Agenda - Executive Policy Committee – June 19, 2013

Report - Standing Policy Committee on Property and Development – June 11, 2013

Item No. 5 Amendment to Servicing Agreement AG 37/2008 – Seasons of Tuxedo (Charleswood-Tuxedo Ward) File DASZ 37/2008

Title: **PROPOSED AMENDMENT TO DEVELOPMENT AGREEMENT AG 37/2008 (DASZ 37/2008) – SEASONS OF TUXEDO**

APPENDIX "A" – DASZ 37/2008 – map

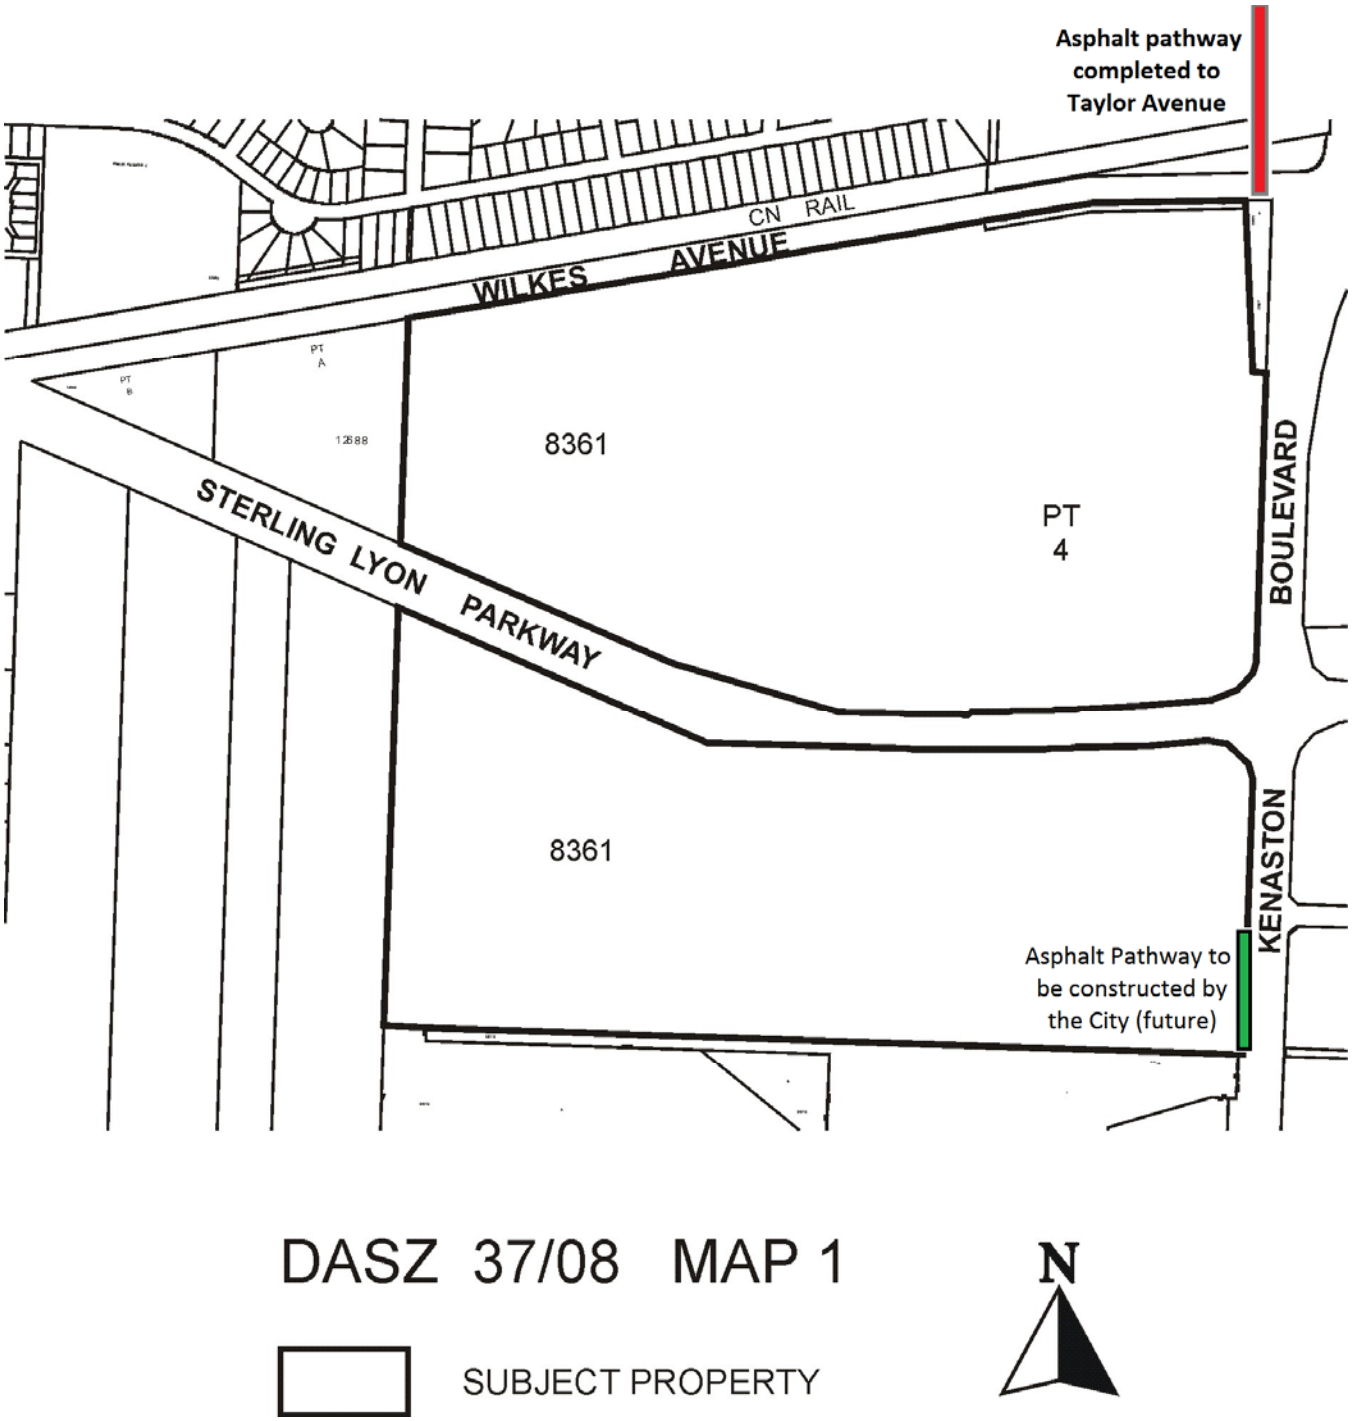
On September 14, 2009 the Developer, Tuxedo Yards Development Corp., entered into Development Agreement AG 37/2008 with the City establishing development conditions to serve the Planned Area as shown on attached Appendix "A" for their Seasons of Tuxedo Development.

Clause 20 of Section I of Schedule "C" of Servicing Agreement AG 37/2008 requires the developer to construct a 3.5 m wide asphalt pathway the full length of the Planned Area along the west side of Kenaston Boulevard.

The Developer has constructed an equivalent length of asphalt pathway along the west side of Kenaston Boulevard however approximately 136 metres of it is displaced to the north of the Planned Area to facilitate a linkage to the active transportation pathway in Taylor Avenue. In exchange, the City will construct the southerly approximately 136 metres in the future when the asphalt pathway is extended further south along Kenaston Boulevard. The Winnipeg Public Service concurs with this requested amendment.

The Developer shall, at no expense to the City, construct a 3.5-m-wide asphalt pathway on the west side of Kenaston Boulevard, from the private approach to the Planned Area opposite Lowson Crescent to the north limit of the Planned Area plus an additional approximately 136 metres north of the north limit of the Planned Area to facilitate the pathway connection to Taylor Avenue, all to the satisfaction of the Director of Public Works.
